## DSP-16057

Application	General Data	
<b>Project Name:</b> Powder Mill Road Consolidated Storage  <b>Location:</b> The north side of Powder Mill Road (MD 212), at the intersection with Cook Road and Powder Mill Road.  <b>Applicant/Address:</b> Arcland 1054 31 <sup>st</sup> Street, NW, Ste. 318 Washington D.C., 20007	Planning Board Hearing Date:	07/27/17
	Staff Report Date:	07/12/17
	Date Accepted:	05/19/17
	Planning Board Action Limit:	07/28/17
	Plan Acreage:	4.86
	Zone:	I-2
	Dwelling Units:	N/A
	Gross Floor Area:	152,269 sq. ft.
	Planning Area:	62
	Council District:	01
	Election District:	01
	Municipality:	N/A
200-Scale Base Map:	214NE06

STAFF REPORT

SUBJECT: Detailed Site Plan DSP-16057  
Powder Mill Road Consolidated Storage

# DETAILED SITE PLAN

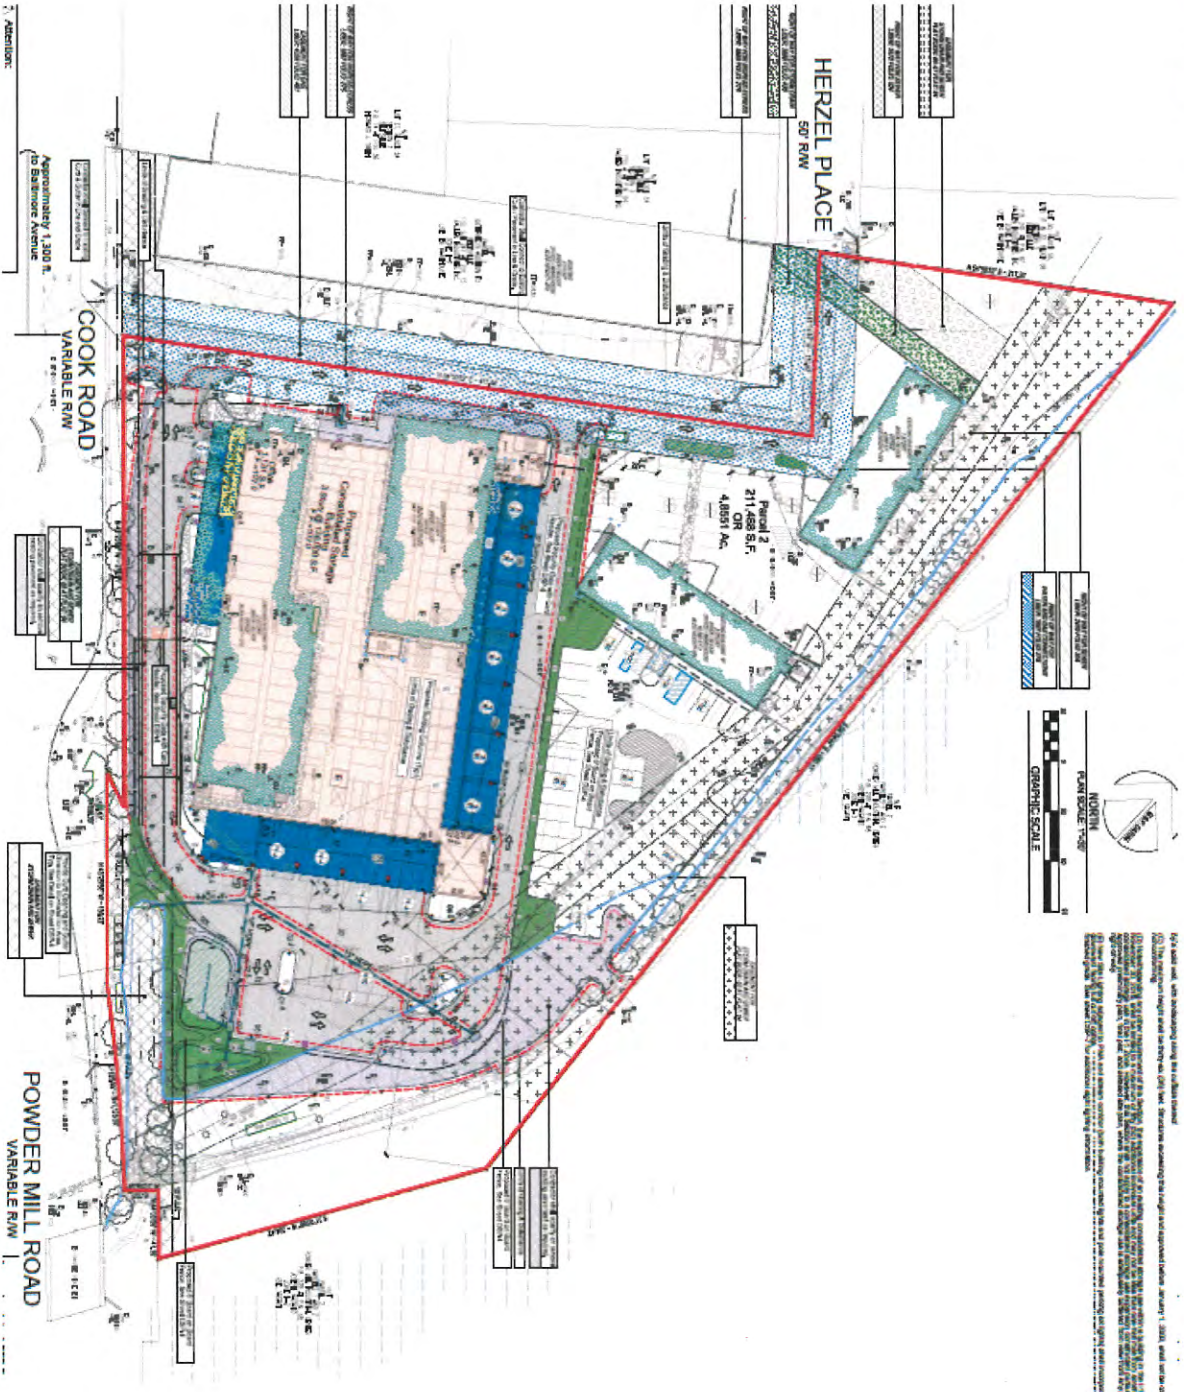
1. The application is proposing to raze the two existing buildings located closest to Cook Road. The plan should be revised to identify the buildings to be razed.

**Comment:** Staff notes that a transition from the two-way ingress and egress of the consolidated storage to the one-way traffic pattern has not been proposed with this site plan, and this potentially creates a circulation problem on-site. The additional 11 feet proposed by the Transportation Planning Section would allow for this transition. The plans should be revised to include a drive-isle transition, which merges into the one-way traffic pattern from the two-way drive isle at the entrance of the consolidated storage on the southeast side of the building, or work with the owner of the adjacent parcel to create an access easement, to be recorded in the Prince George's County Land Records, if it is necessary.

1. Prior to certificate approval of the detailed site plan, the applicant shall revise the Detailed Site Plan to:
  - a. Show the location of this freestanding sign, or remove the detail from the plan.

# LANDSCAPE PLAN

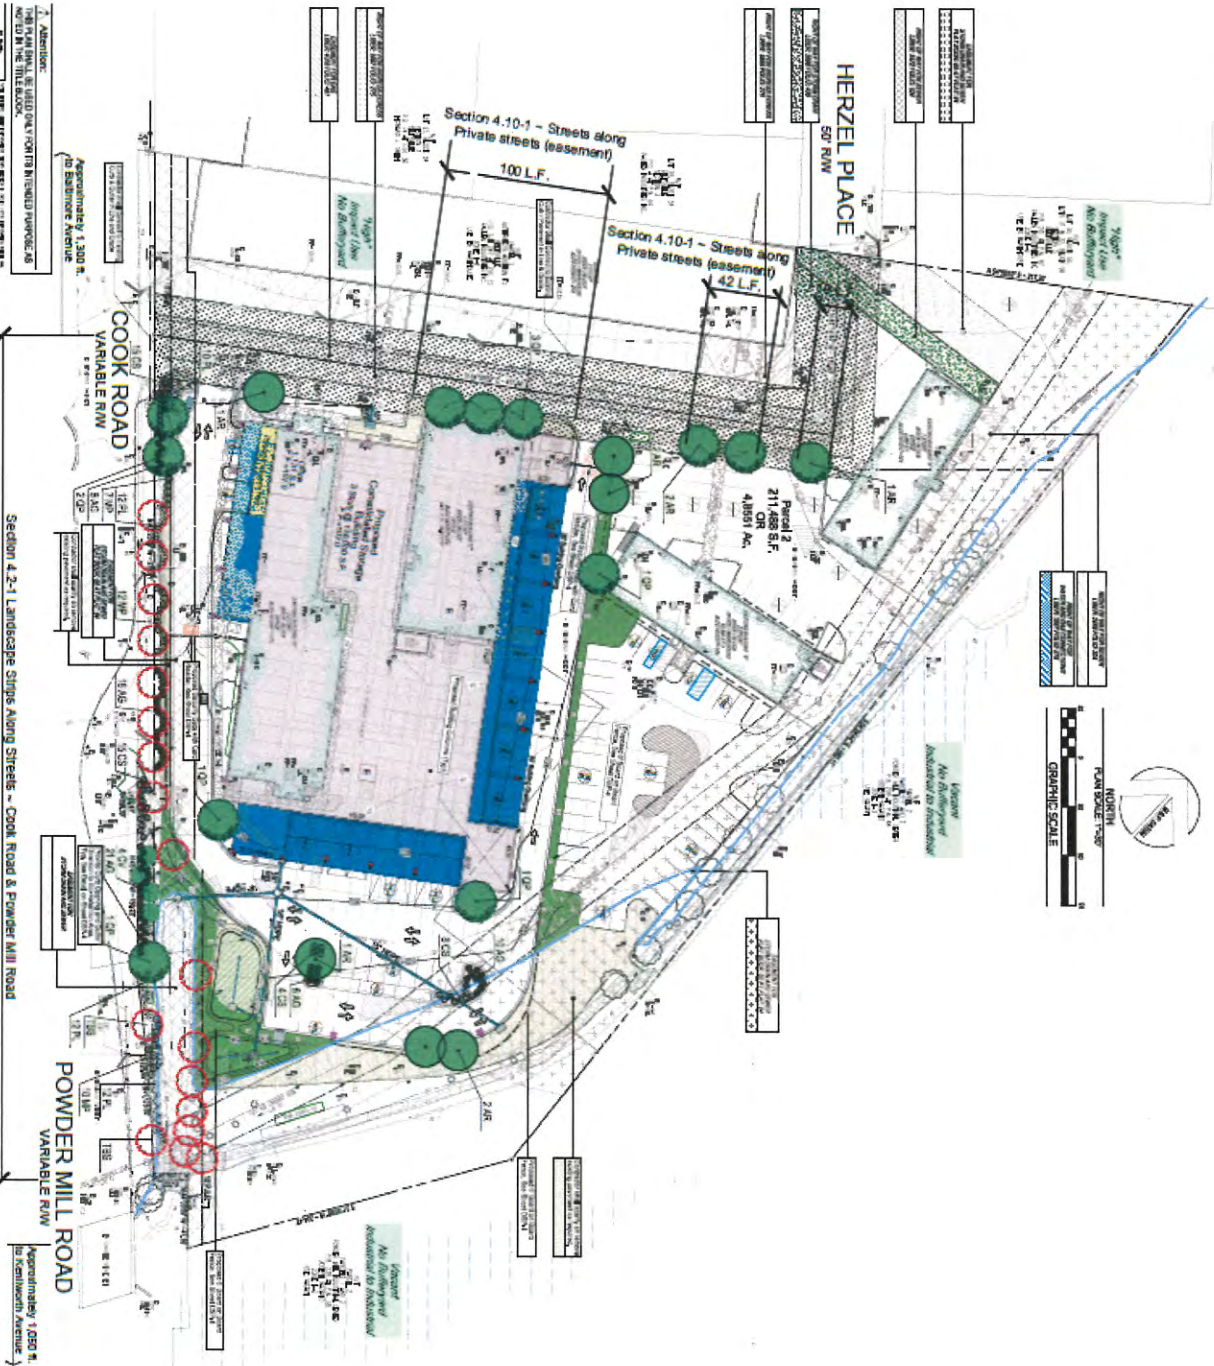
however, the plans do not provide a label showing the dimension of road frontage and should be updated prior to the certification. A condition has been included in the Recommendation section of this report to provide the length of the 4.2 buffer on the landscape plans. The length of this landscape strip requires that 15 shade trees and 149 shrubs be provided. This application meets this requirement and proposes 23 shade trees, 4 ornamental/evergreen trees, and 152 shrubs.

1. Need to add a note with in the Landscape Schedule for Section 4.2-1 along Cook Road and Powder Mill Road that there is overhead wiring along the street to clarify the allowed substitution of plant materials.
2. No sign details submitted for review.

- e. Provide a valid standard letter of exemption from the Woodland and Wildlife Habitat Conservation Ordinance for this property.
  - f. Provide dimensions showing the length of the 4.2 buffer on the landscape plans.

# BUILDING ELEVATIONS

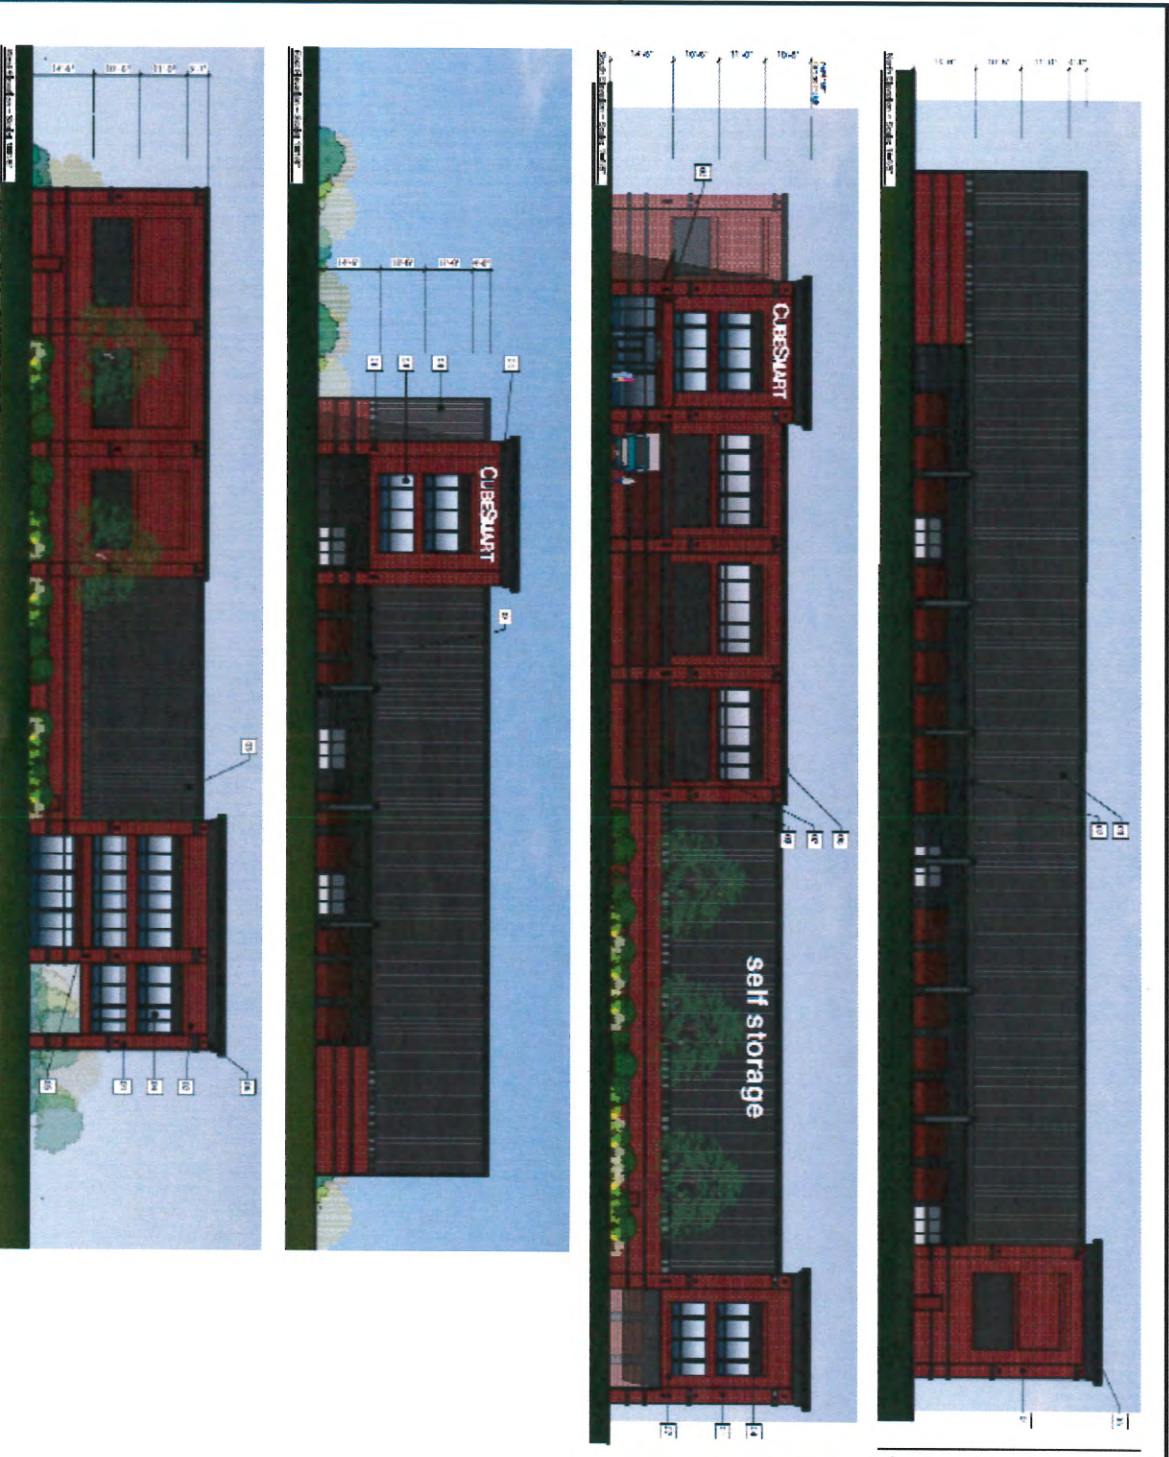
- c. Provide details for the two additional signs shown on the building's south and east elevations, which advertise the tenant's name, and update the sign calculation schedule to reflect their additional signage area.
